# MCP79410 Hours Alarm Issue

Amond Lin  
2024 SEP

# Failure Description

# Time-line : The problem

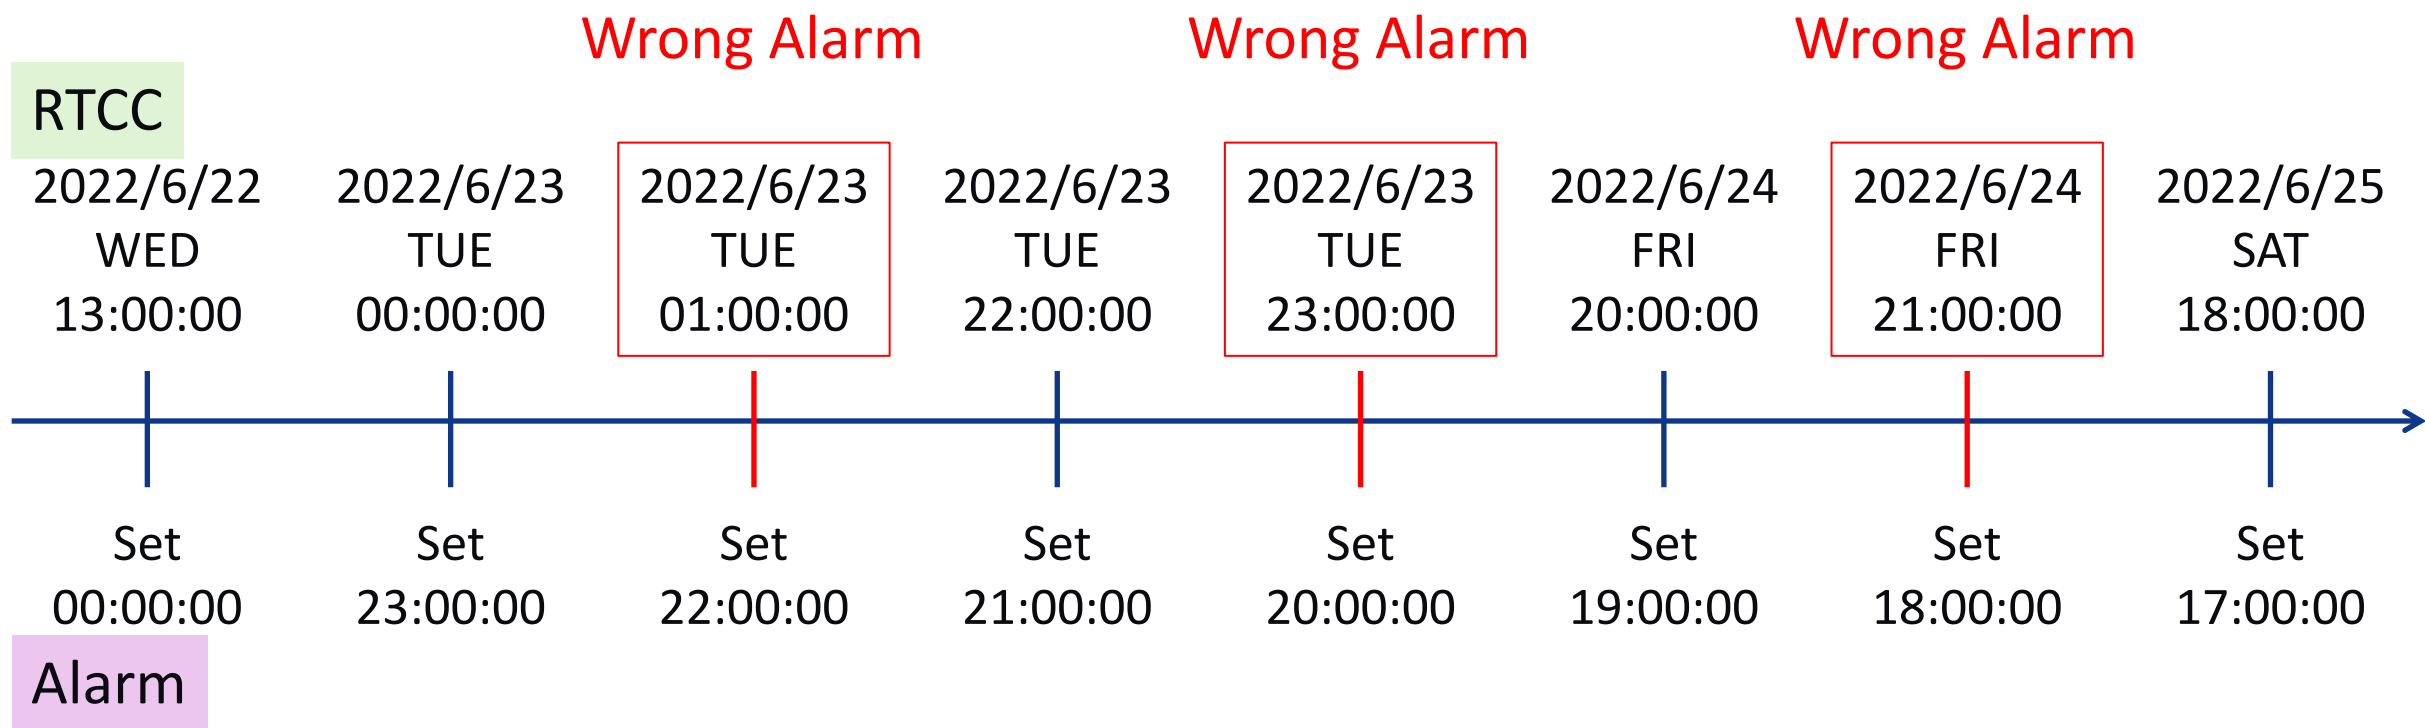
- Initialized date/time with present date/time (2022, JUN, 22, Wednesday, 13:00:00)
- **Configure 1st Alarm time at 0:00.**
- When  $ST(RTCSEC\ bit\ <7>) = 1$ , RTCC would start working.
- When hour-match at 00:00:00,  $ALM0IF = 1$ .
- MCU would config  $ALM0HOUR = 0x23$  and clear  $ALM0IF$ .
- It was expected to get next alarm (let's call 2<sup>nd</sup> alarm) after 23 hours, but 2<sup>nd</sup> alarm would occur again after only 1 hour ( $RTCHOUR = 0x01$ ). **MCU didn't know that, so MCU read and wrote back  $ALM0HOUR (0x23 - 1 = 0x22)$  again and clear  $ALM0IF$ .**
- 3<sup>rd</sup> alarm would occur properly after 23 hours.
- **4<sup>th</sup> alarm would occur after only hour again.**
- 5<sup>th</sup> alarm would occur properly after 23 hours.
- **6<sup>th</sup> alarm would occur after only hour again.**
- And so so...until MCP79410 was power-down.

# Timing sequence from client (1/3)

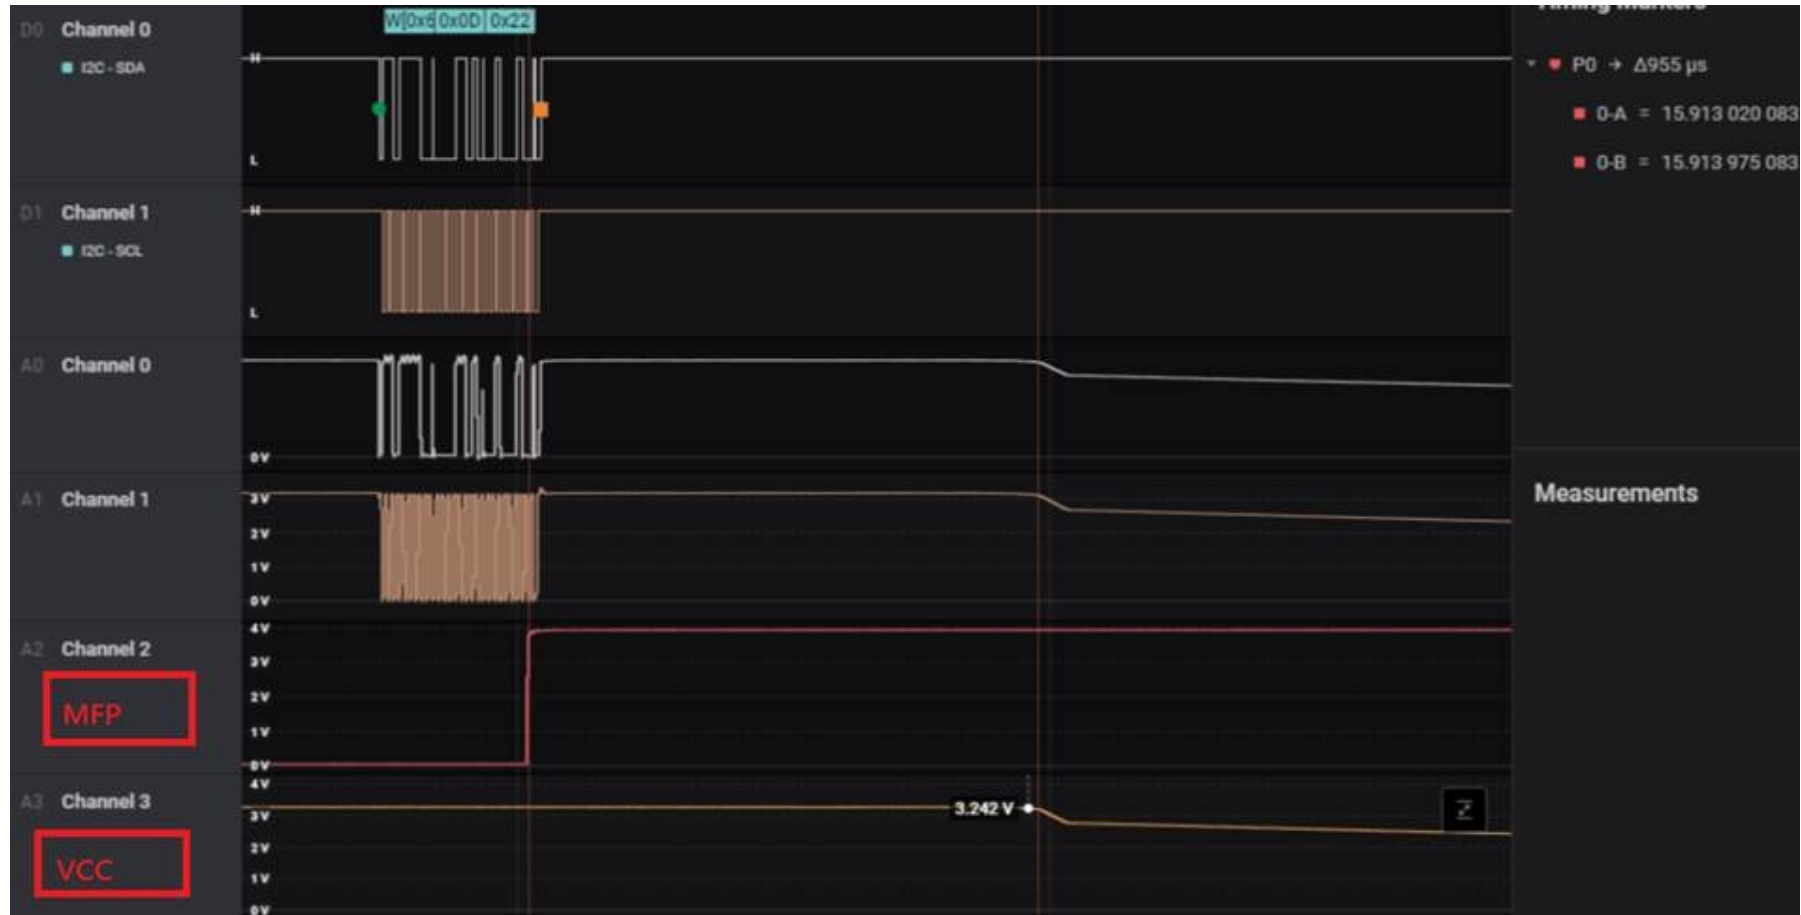
- Q: Once ALM0IF was cleared, MFP would be pull-high immediately. Was the last frame sent completely before MCU was off?

- VCC would start falling down after 955ns with MFP pull-high.

- Slide 22, the VDD falling after MFP going high is OK, slide 23 VDD fall rate is fine, not too fast or too slow, exponential decay is typical for many systems. How long until the power is restored and what does the VDD reach just before it is turned on? Does it really reach 0V?

# Timing sequence from client (2/3)

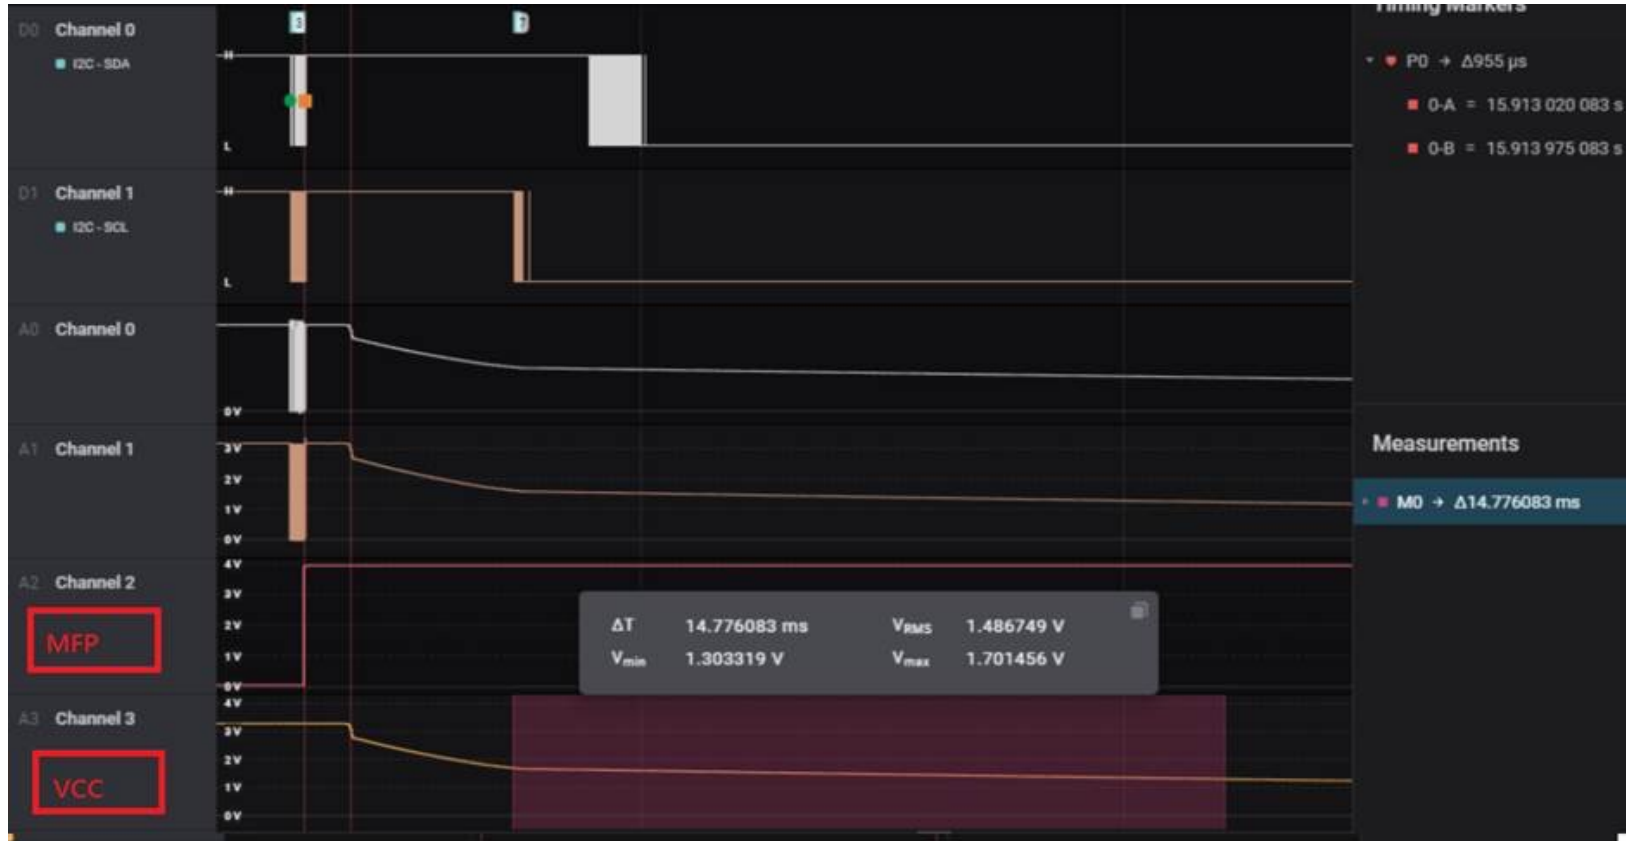
- When VCC was powered down (RTC got to sleep), VCC down from 1.7V to 1.3V would take about 14ms to compare with T15 on data sheet.

# Timing sequence from client (3/3)

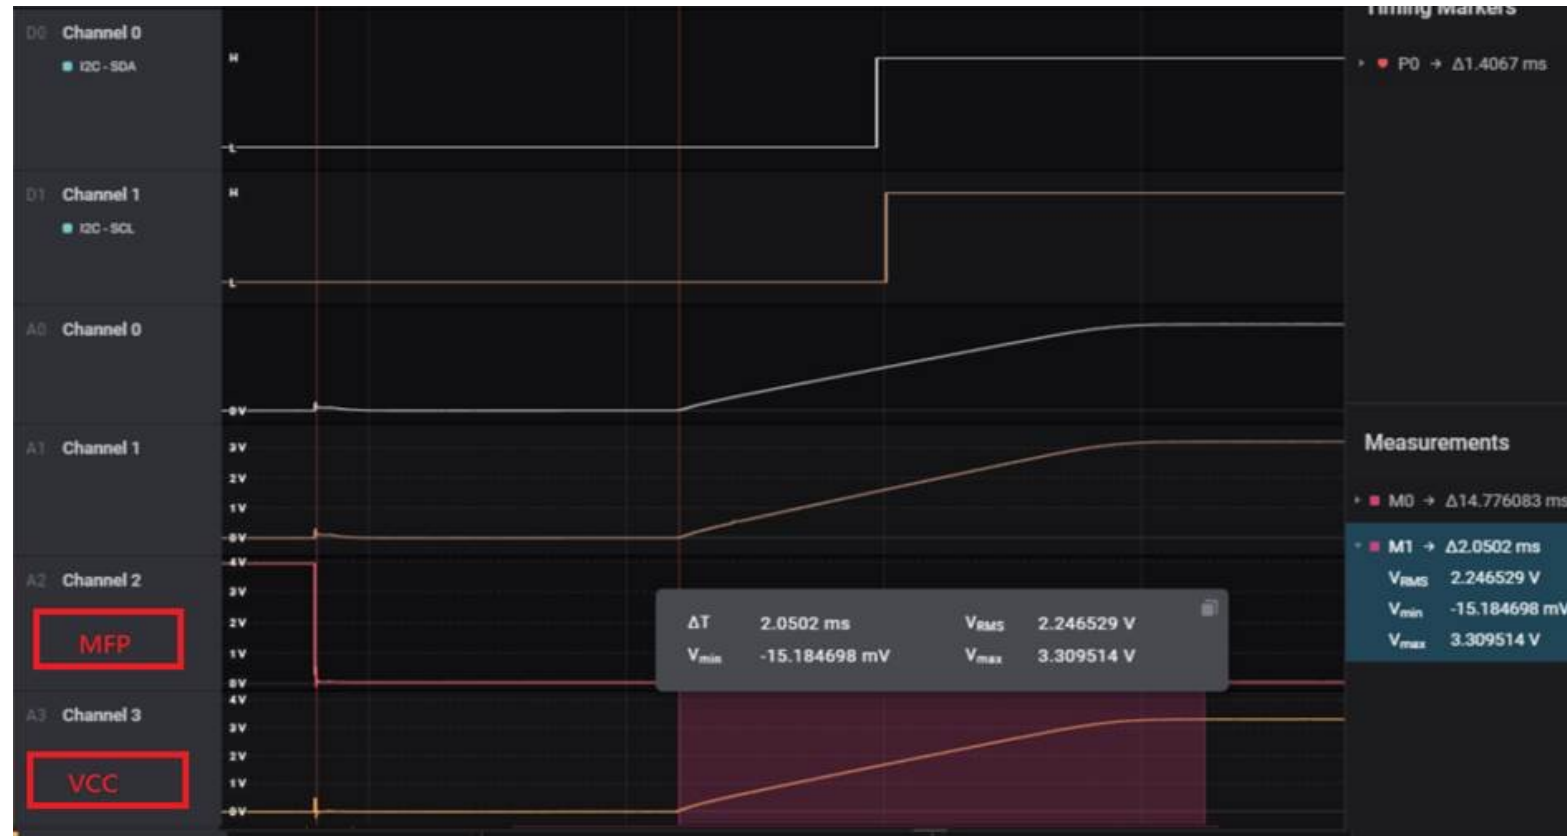
- When RTCC waked up, MFP was low. Right after 14ms, VCC started going up from 0 to 3.3V to compare with T16 on datasheet.

- Slide 24, VDD is powered on and MFP is low. Is this what is expected? If the MFP was high on power down, shouldn't it be high on power up? What changed here to explain this?

- Ans: The VDD circuit would be enabled by MFP with active-low. But it is true that MFP could be possibly high by pull-up resistor **before initializing RTCC (Step3, slide 34)**. After RTCC was initialized, MFP would be certain with active-low and normal high two mode. **When MFP = high, power source of RTCC will be from battery only in power saving mode of unit, and it will be from both of battery and VDD in working mode of unit.**
